APPLICATION/APEAL TO THE BOARD OF ADJUSTMENT

Case No.: BDA 234-106 **RECEIVED**
FOR OFFICE **JUL 19 2024**
BY:

Location address: 1800 S. Ervay St Zoning District: PD-317

DULCE NINA AT THE CEDARS
 1800 S. ERVAY
 Dallas TX 75215

1 SITE PLAN
 SCALE: 1/8"=1'-0"

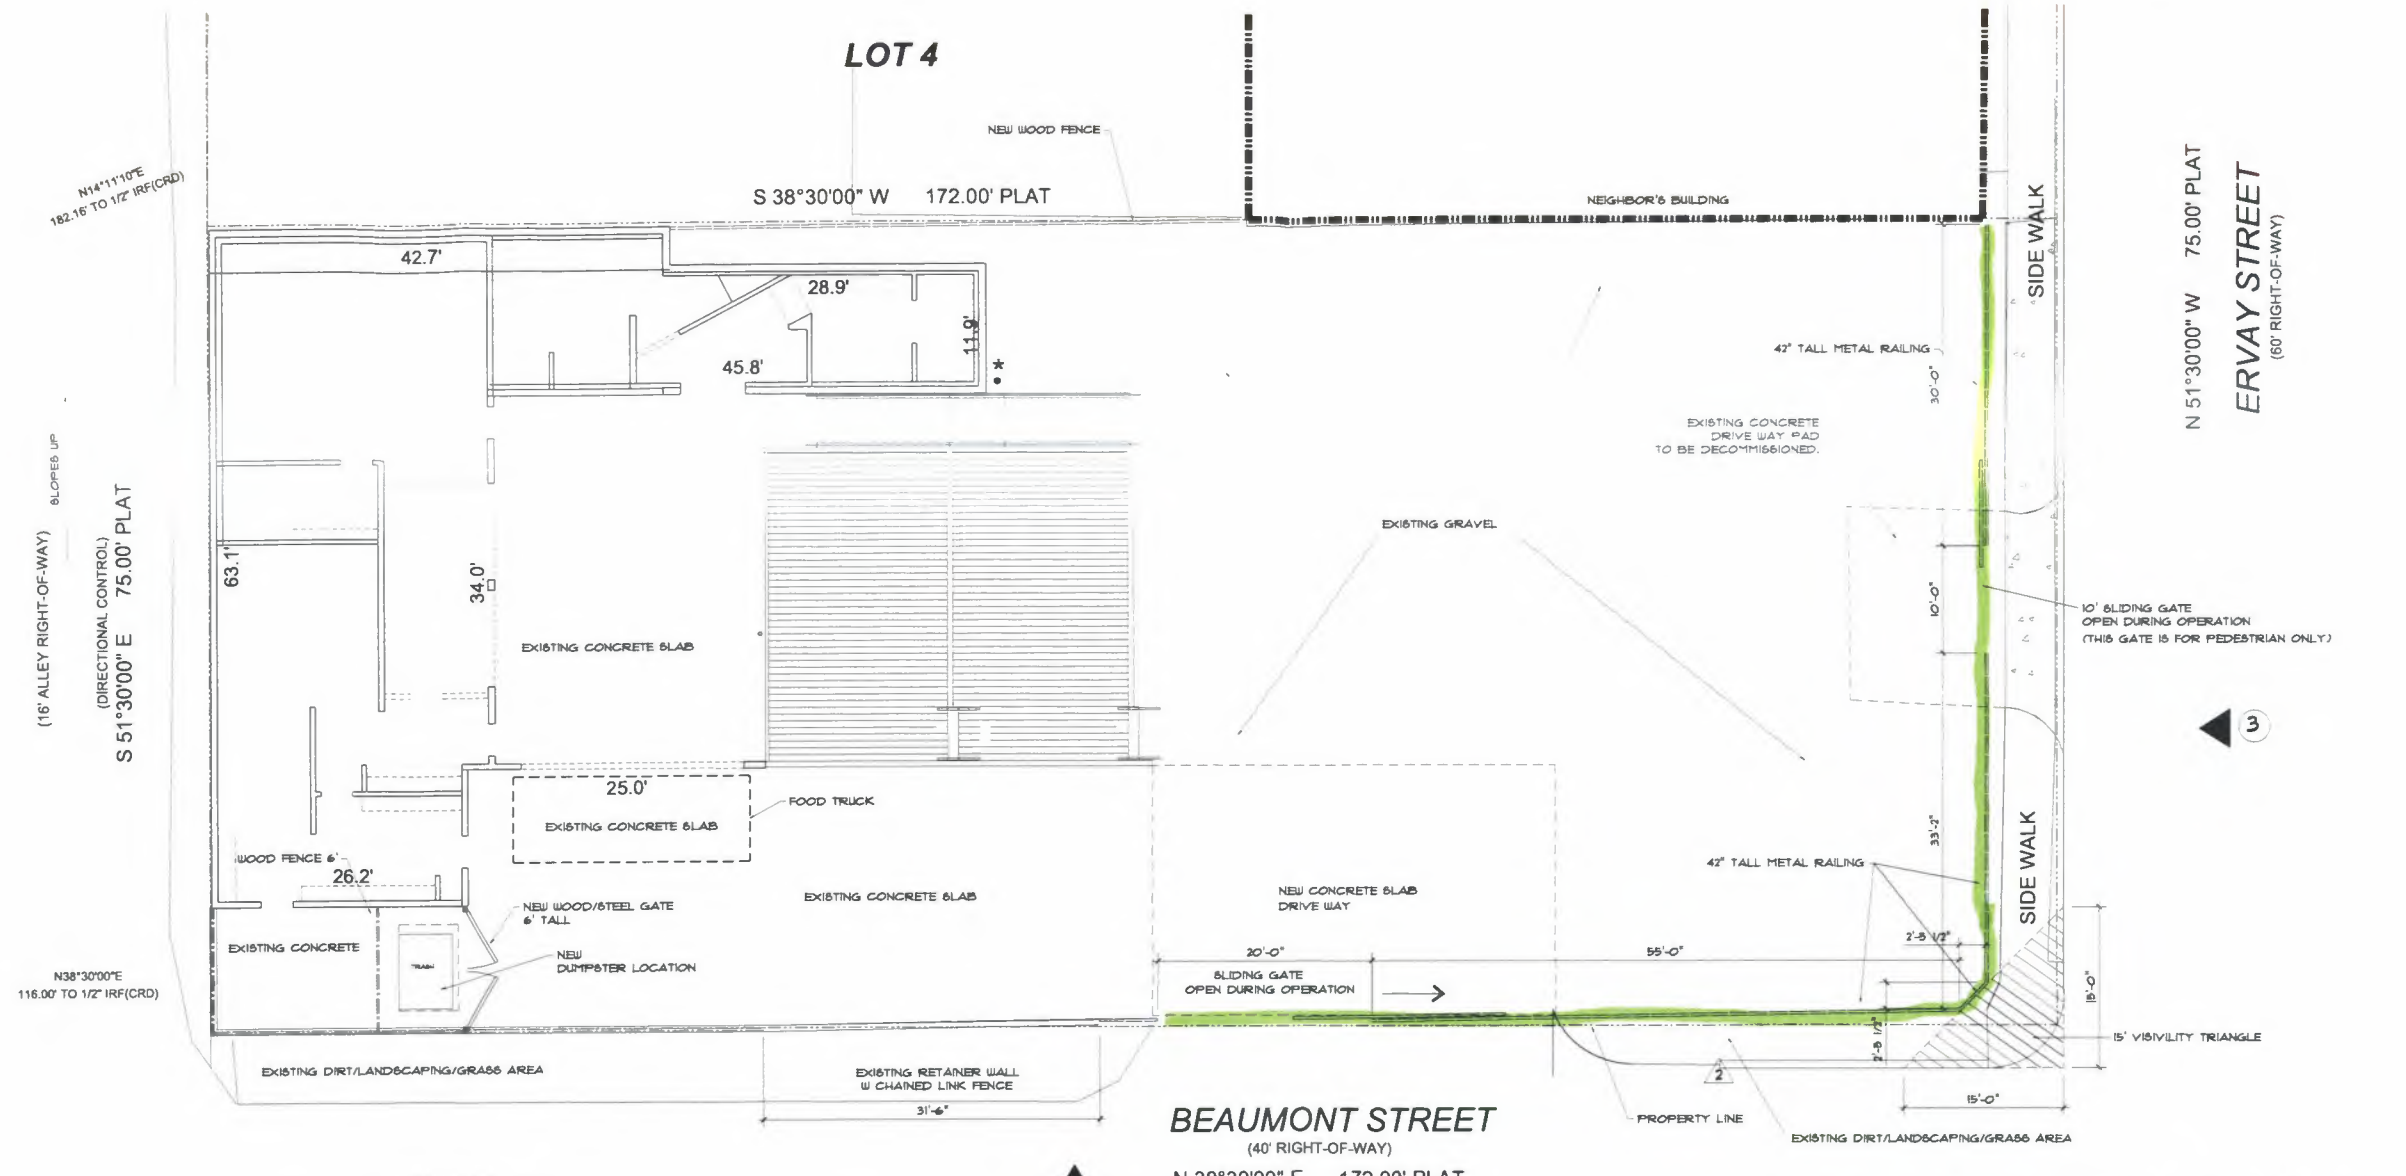
NOTES/COMMENTS: 1) Need to edit the request in the application for three requests!
2) Provide us Elevation seperately!
3) sit plan NTS
